**FP802-160044**

**Subject: Invitation to Tender: FP802-160044**

**Title: Cathodic Protection Works**

**ADDENDUM: NO. 01**

**FIGURE 1**

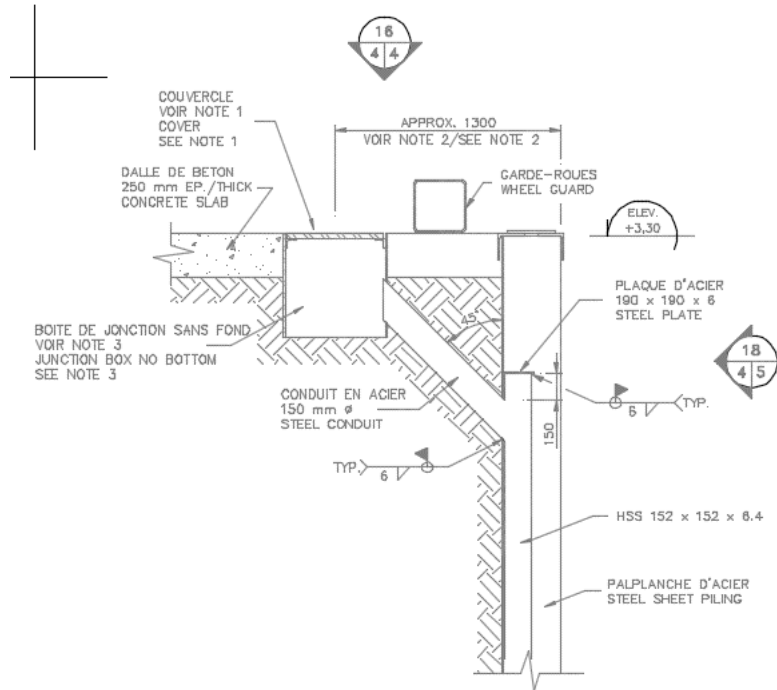
Are the pulling wells BJ1 @ BJ7 existent? If so, what is the number and size of the pipes between each well?

Installation of BJ1 to BJ7 pulling box are part of the work to be completed in this project.

\*See Figure 1 below

**Distance between pulling box :**

- BJ1-BJ2 = BJ2-BJ3 = BJ3-BJ4 = BJ5-BJ6 = BJ6-BJ7 = 36m
- BJ3-BJ4 = 29m
